CITY of NOVI CITY COUNCIL

Agenda Item 2
April 7, 2008

SUBJECT: Consideration of the request of Best Buy for (a) Special Land Use and (b) Preliminary Site Plan approvals. The subject property is located in Section 14, on the east side of Novi Road, between I-96 and Twelve Mile Road. The subject property is approximately 3.3 acres and the applicant is proposing to remove the closed bank and furniture store and construct a 30,891 square foot Best Buy store.

PLANNING REVIEW

SP-2

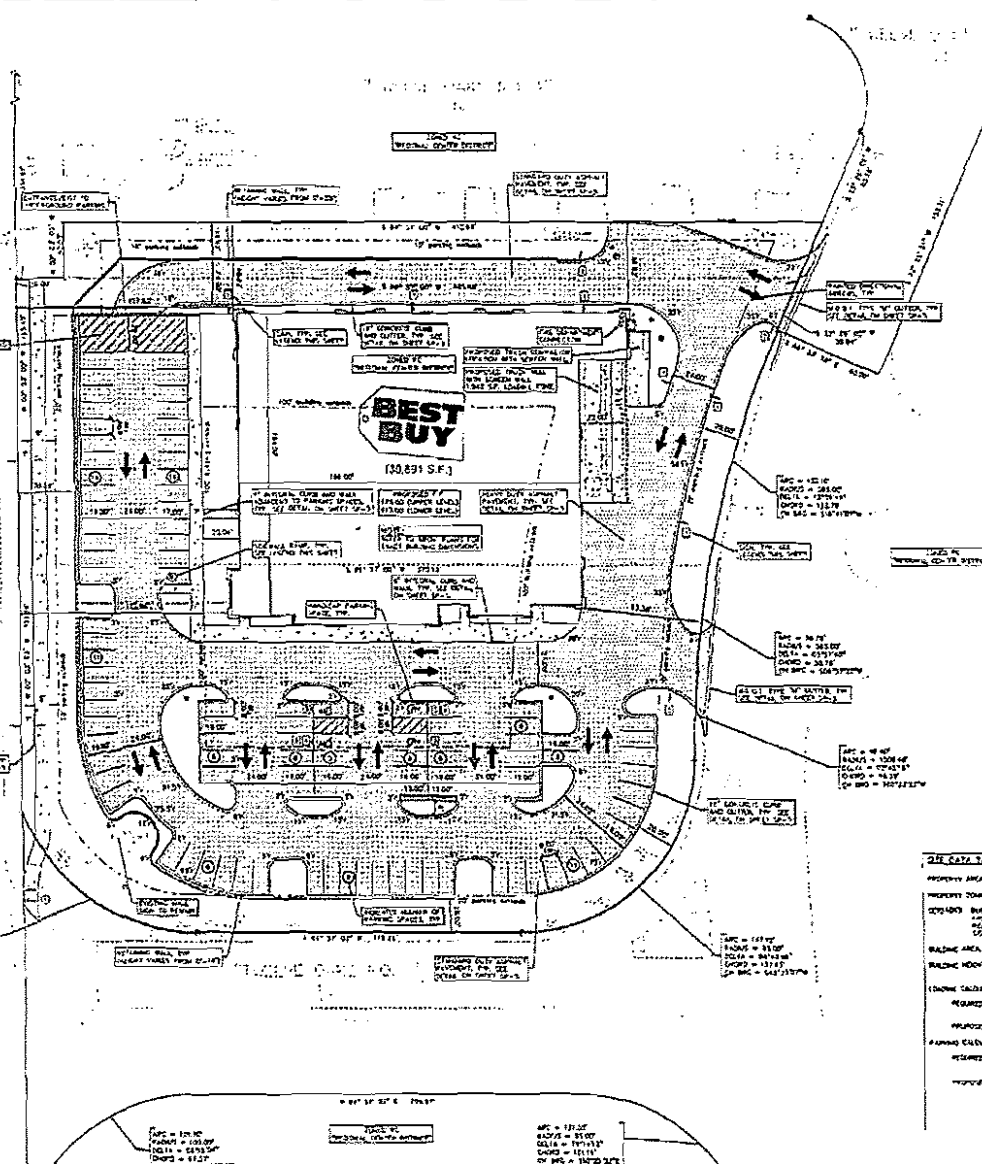
7. Sign Mounting Height: The mounting height of all signs should be 7' from the grade level to the bottom of the parent sign. The correction should be made for "Sign and Post Installation in Paved Areas" detail on sheet SP-5.
